Groundwater & Wastewater Services
Septic Project File & Data Review Worksheet

GWS File #: 67773 WASPS App #: 2261

RE: Request for an Improvement Permit for Lot 39 at The Retreat at Latta Plantation off of Sample Road.
MCHD File #6777B

Design Specifications for Lot 39 off of Sample Rd.
MCHD File # 6777B

Scale: 1 inch equals 50 feet	S&ME	Faison-Sample Road, LLC	FIGURE
Drawn by: JBP		Lot 39	1
Reviewed by: Jeremy P. Michelone, RS		Mecklenburg County, NC	
Date: March, 2007	ENVIRONMENTAL SERVICES · ENGINEERING · TESTING	S&ME Project #1588-05-091

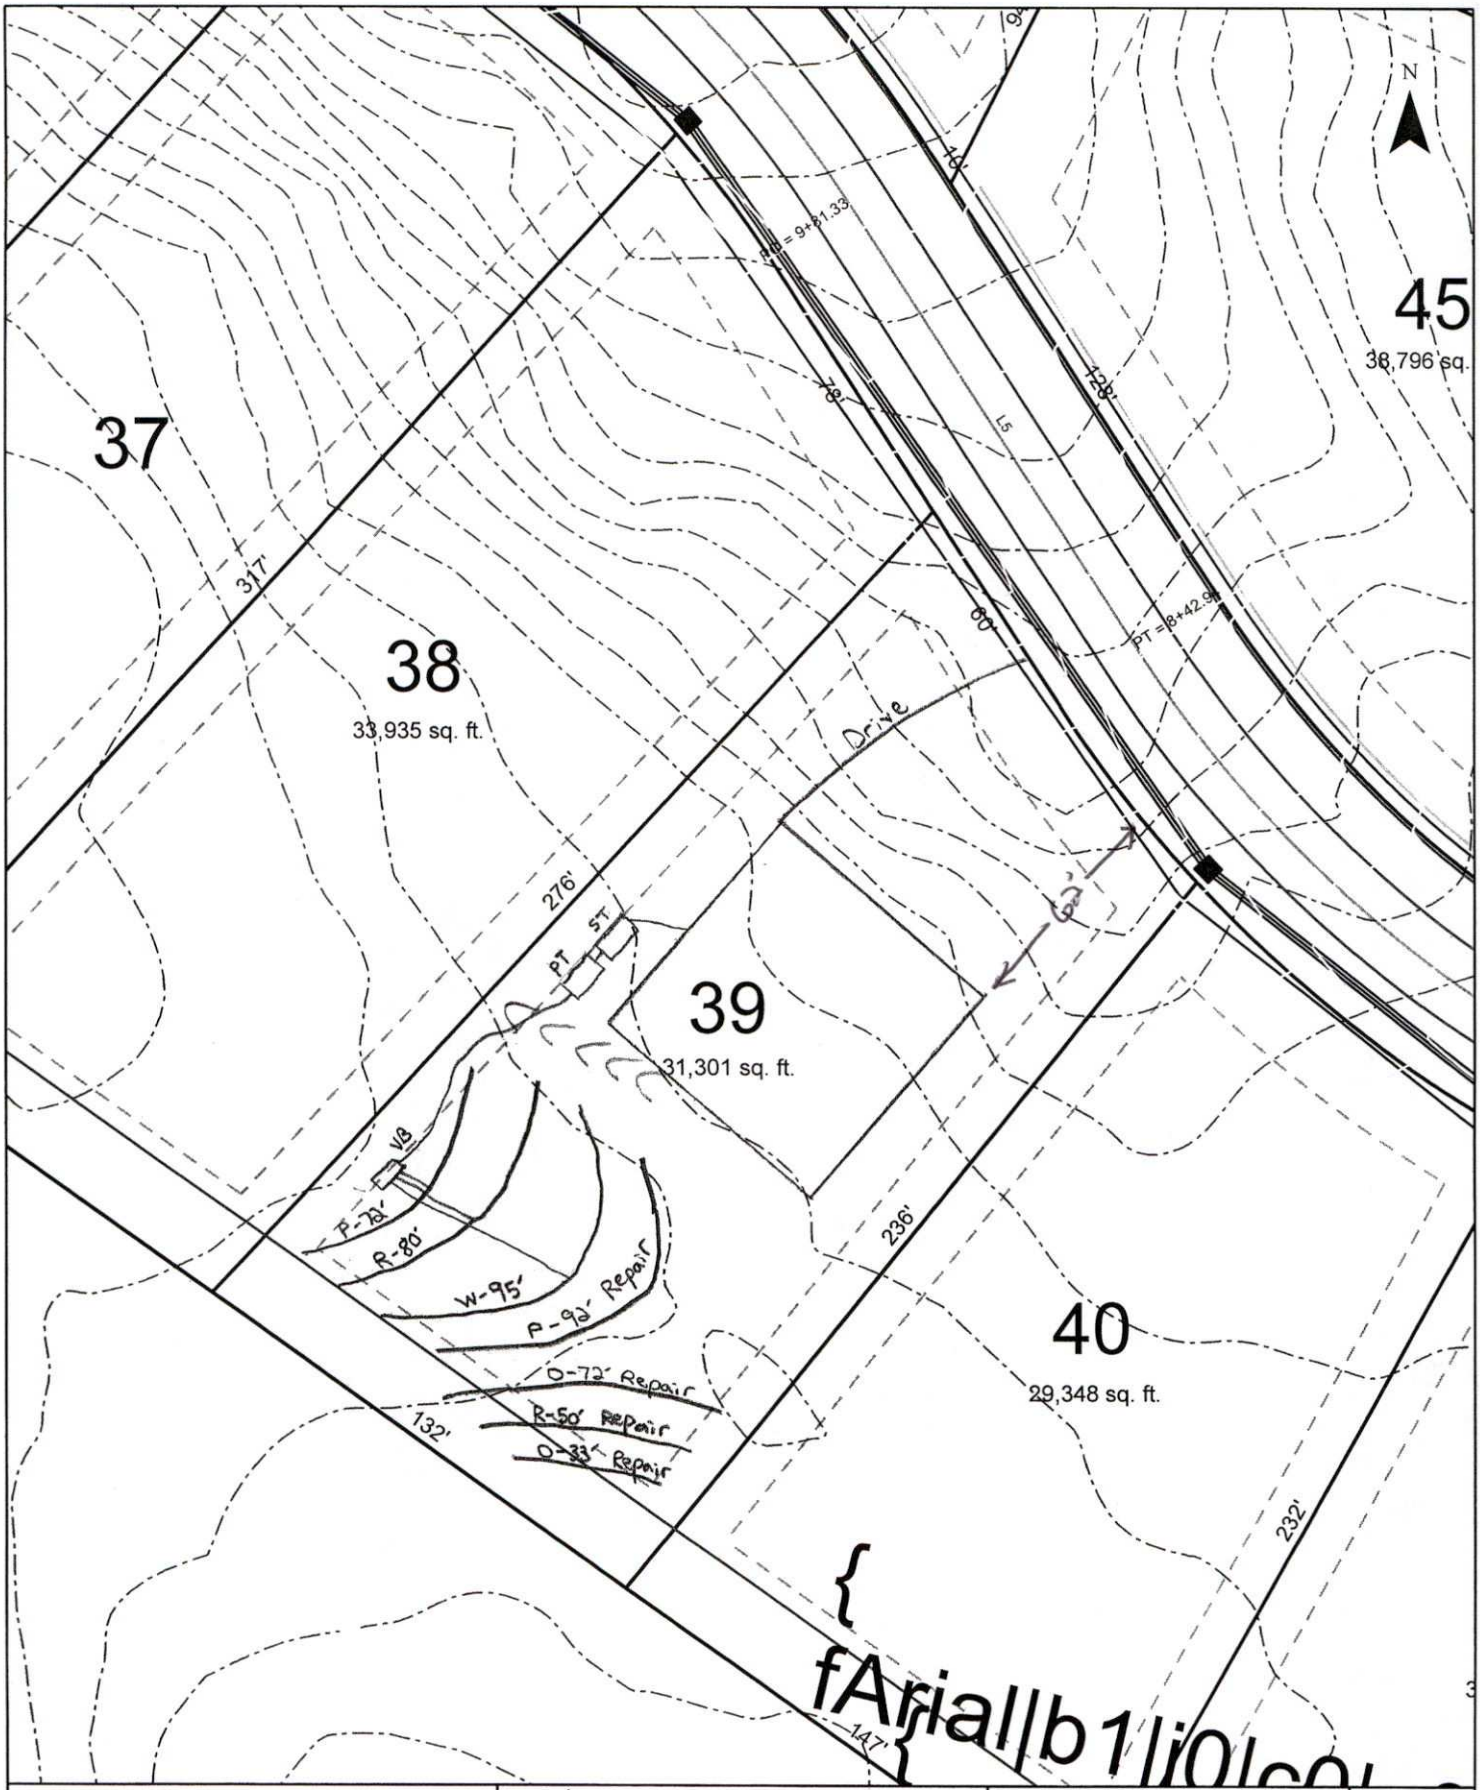
Comments:

1. Install system using 3 ft. wide trenches.
2. Install drainlines on 9 ft. centers, level, and on contour.

3. System design requires effluent pump for distribution.								
4. 100% Repair area is required.
